DEVELOPMENT REVIEW BOARD MEETING
MONDAY, JULY 27, 2026
6:30 PM

**DEVELOPMENT REVIEW BOARD
RESOLUTION NO. 448**

Exhibit A1
Staff Report
Wilsonville Planning Division
PGE Pearl-Sherwood Transmission Line Upgrades
Development Review Board Panel 'B'
Quasi-Judicial Public Hearing

Hearing Date:	July 27, 2026
Date of Report:	July 20, 2026
Application No.:	DB25-0007 PGE Pearl-Sherwood Transmission Line Upgrades
Request/Summary:	The requests before the Development Review Board include a Conditional Use Permit, Site Design Review, and Type C Tree Plan.
Location:	The property is specifically known as Tax Lot 601, Section 2B; Tax Lots 400 and 600, Section 2CA; Tax Lots 301, 303, 304, 500, and 600, Section 2CD, Township 3 South, Range 1 West, Willamette Meridian, City of Wilsonville, Washington County; and Tax Lots 2100 and 2200, Section 11, Township 3 South, Range 1 West, Willamette Meridian, City of Wilsonville, Clackamas County, Oregon
Owners:	Garydel LLC, CCWB LLC, Eghdami Rental LLC, Stafford DC LLC, and Bonneville Power Administration (BPA)
Applicant:	Portland General Electric (Contact: Meredith Armstrong)
Comprehensive Plan Designation:	Industrial, Public
Authorized Representative:	Da

Tree Removal and Power Lines

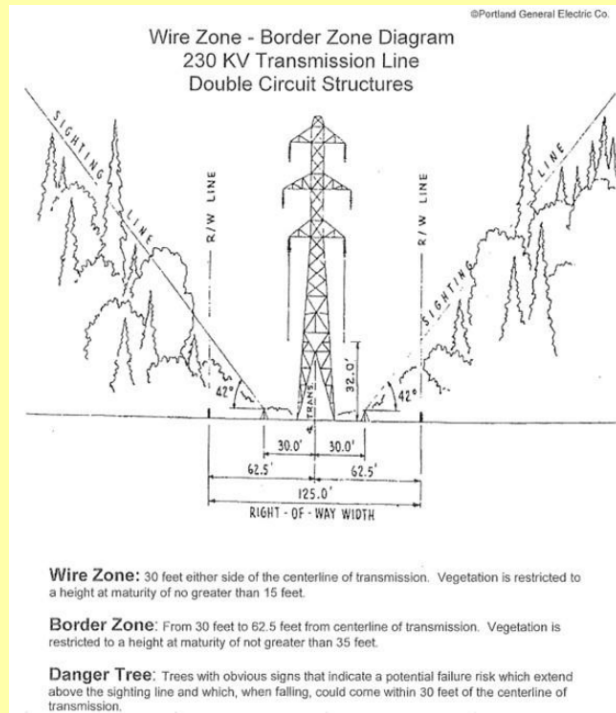
The applicant proposes to remove six (6) trees that are located on the property line of 9565 SW Ridder Road due to their proximity to the proposed high-voltage powerline. The National Electrical Safety Code (NESC) Rule 218 and PGE Transmission Vegetation Management Policy require that trees in the "wire zone" (within 30' on either side of a transmission line) be no taller than 15' at maturity and that trees in the 'border zone' (between 30' and 62.5' from the centerline of a transmission line) be no taller than 35' at maturity. The six (6) trees proposed for removal are between 33' and 37' from the transmission line wires putting them at the edge of the border zone and therefore requiring that their height be reduced to 35'.

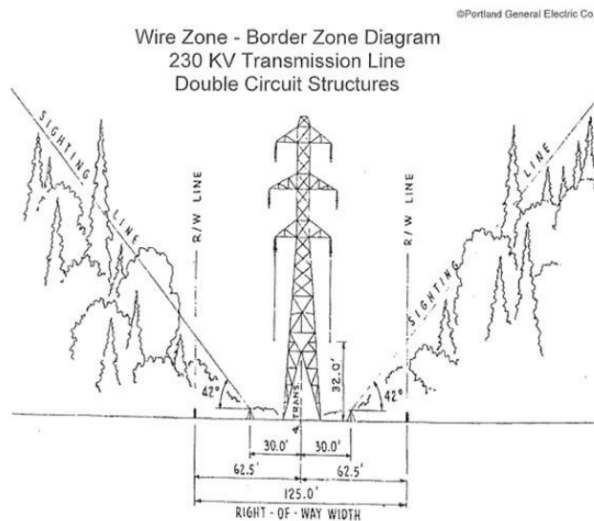
- **Development Alternatives:** The proposed tree removal has been minimized to the extent possible in order to accommodate the proposed modified powerline pathway. The National Electrical Safety Code (NESC) Rule 218 and PGE Transmission Vegetation Management Policy require that trees in the “wire zone” (within 30’ on either side of a transmission line) be no taller than 15’ at maturity and that trees in the ‘border zone’ (between 30’ and 62.5’ from the centerline of a transmission line) be no taller than 35’ at maturity. The six (6) trees proposed for removal are between 33’ and 37’ from the transmission line wires putting them at the edge of the border zone and therefore requiring that their height be reduced to 35’. Preservation of these trees, especially the two (2) previously retained Douglas fir which are 87’ and 92’ in height, would require significant crown reduction to 35’ that would result in tree mortality.

Wire Zone: 30 feet either side of the centerline of transmission. Vegetation is restricted to a height at maturity of no greater than 15 feet.
